PŪMANAWA DOWNTOWN WEST

LANEWAYS CPTED REVIEW

DRAFT V1. 1 September 2023

FIG.6 Laneways CPTED Key Plan

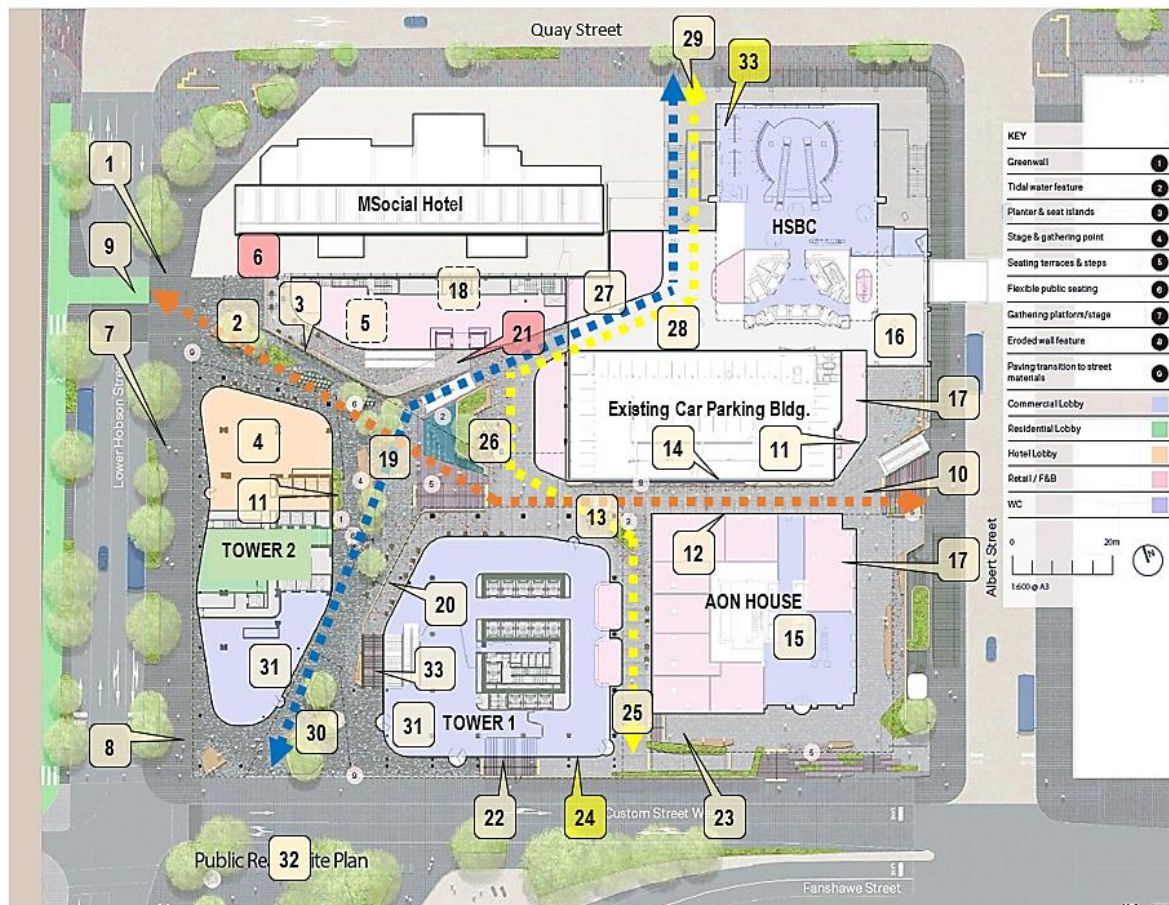
- ✓ Good wide open, obvious and legible, node-like connection [1] to the Lower Hobson Street footpath;

- ✓ The section between the west entry node [1] and the central 'urban room' [2] is also visually open and legible;
- ✓ It has an activated retail frontage [3] and provision for inside and outside edge dining and internal and external tables [4] associated with the hotel on the north edge of Tower 2;
- ✓ There is sufficient space between the adjoining building edges, planters and seating, and the pathways themselves to provide movement line choices and obviate encroachment into personal space for any of these activities - so as not feel like one is 'running the gauntlet' as can occur in tighter inflexible environments;
- ✓ The northeast entry section is also overlooked from the public space and dining spaces associated with F&B immediately above on Level 01 in the northeast corner [5].

- R Improving the appearance and safety of the service entrance [potentially anti-social eddy] to the rear of the hotel [6] immediately adjoining and therefore affecting perceptions of quality, amenity and safety at this important part of the Project Area.

- R The quality of the connection beyond the Project Area, and therefore the extent of use and activation of the laneway and Project public realm will depend on improving the Lower Hobson Street footpath environment [7] through to Customs Street West [9], and across Lower Hobson Street to link with the Viaduct Precinct as anticipated in the design. Should the Flyover be removed, this would greatly improve connectivity, safety and perceptions of security-for-safety that are currently compromised by the dark, relatively impermeable undercroft and roadways.

- ✓ Clear views west to the exit on Lower Albert Street; and -
- ✓ in the east to west direction the green wall [11] acts as a useful orientation 'beacon';
- ✓ Glazed edge, proposed F&B outlets adjoin the southern edge of the laneway [12] providing a more generous sense of aisle width and activation and natural supervision;
- ✓ An intermediate node [13] which connects with the north-south laneway provides an exit choice. It also promotes more activation with centrally placed seating and planters. The Design Team promoting this as a dwelling eddy and pause point is supported from the CPTED perspective¹³;
- ✓ Personal and disengagement space provided by a minimum 3 metres (net) clear movement zone, appears to be adequate;

- ✓ The 'eroded' feature wall of the existing car park along the northern side [14] of the laneway provides significant artwork, interest, pocket seating caves¹⁴ and activation potential – devices which together with the [above-mentioned] node/exit point - can help to reduce perceptions of length – and transform the laneway into an interesting long room;
- ✓ This section of the laneway will also be significantly activated by people coming and going to the Aon House tower entrance [15] and lift lobby;
- ✓ The generously sized entry/exit node at the top of the steps and escalator from Lower Albert Street [10] is also overlooked and activated by foot traffic through into the public lobby and circulation area [16] of the HSBC. There are also F&B outlets [17].

- ✓ For good views in advance of travel and preventing lurking at corners, the connections between straight sections and nodes are potentially transparent (depending on window treatments) and flared e.g. around AON House and Tower 1;
- ? Query whether good access to a public toilet would be an advantage to support the public realm and to minimise the risk of soiling afterhours? Are the five self-contained units in the northwest corner on Level 01 [Grids C1, C2 – CF, CG – [18]] intended to support the entire public realm on Levels 00 and 01? Toilets are essential collateral to support people staying within the building.

- ! Public lift lobby [21] is generously spaced but has limited supervisory views due to the dogleg in plan and being beneath an undercroft – (see below).

- R Recommend reviewing the approach to and alignment of the frontage of the lifts – ideally to be part of and to face the urban room given the importance of the lifts for supporting the Eastern Laneway end-to-end.
- ? Query whether good access to a public toilet would be an advantage given that the F&B establishments, albeit few in number adjoining the Urban Room on Level 00, currently do not appear to have such facilities?

- ✓ Broad stairs clearly signal a major entrance – like the others off Lower Albert Street - and encourage access from Customs Street West; but –
 - ? perhaps this relies on learned experience to relate the stairs to the entrance to the North-south lane - the glazed canopy between Tower 1 and AON House helping with this, but may not be read as such from street level;

- ✓ The undersides of the Customs St. West stairs are filled-in to eliminate undercrofts;
- ✓ The junction of the stairs and the footpath is well offset from the entrance to the service lane [24] [discussed later]; which gives greater clarity of purpose of occupants on or near them respectively;

- ✓ The Customs Street West entrance node [25] on Level 01 is also activated by and forms the western part of the southern podium [23] of AON House;
- ✓ The section from the southern node on Level 01 extends directly to the central node [13] shared with the eastern laneway, visually and physically bookended by its feature eroded wall [14].

- ✓ Both sides of this section of the laneway are clear and uncluttered, have no potentially problematic recessed doorways and are highly activated and naturally supervised by the glass shop-fronted F&B establishments on both sides;

- ✓ The northern entrance [29] is well articulated by its placement between the tall ends of the MSocial Hotel and the HSBC Building, plus the node on the Quay Street footpath and the prominent almost ceremonially broad steps. And seemingly [from the render] identified by suitable lighting at night;
- ✓ The transition from the base of the steps to Quay Street transitions well, with physically and visually open corners, and –
- ✓ this useful orientation node at the base of the steps on the Quay St footpath is separate and legibly distinguished from the entrance into the service lane to the east. It would help legibility and visibility if all the plants in the central seat/planter were like the taller undercut trees shown in the render.

- ✓ The central urban room is clearly visible as a destination from the Customs Street West entrance and vice versa;
- ✓ The entrance is well activated and naturally supervised due to the adjacency and visual transparency of the entrances to Tower 2 and Tower 1 respectively [31];
- ✓ The entrance is also activated by the link [32] across Customs Street West and Sturdee Reserve to Fanshawe Street albeit that Fanshawe Street currently presents a significant barrier to the CBD to the immediate south (WAM. TAG.03. Part 2, s.2.12. (p.7);
- ✓ Stairs [33] are also provided near the entrance to allow direct access to the upper level (01) of urban room public space from which point there is a choice for continuance between the Eastern Laneway to Lower Albert Street, or the

- 4.14. The service lane [24-33] currently allows a poor-quality, informal, north-south pedestrian shortcut between Quay Street and Customs Street West. It is not designed as a pedestrian thoroughfare and is very utilitarian in character commensurate with the nature of servicing and predominantly vehicular, back of house access.

- R expressing the entrances on both sides as service entrances by means, for example, of paving thresholds – ideally where the footpath paving ‘masters’ the vehicle surface;
- R eliminating or otherwise treating any entrapment spaces, cul-de-sacs and the like e.g. the AON corridor alongside the lane to the immediate right of Grid AK;
- R controlling access to private ramps and dockways;
- R support from security technology such as card access control and monitored CCTV;
- R lighting suitable for security and for a vehicular thoroughfare as distinct from encouraging public pedestrian thoroughfare;
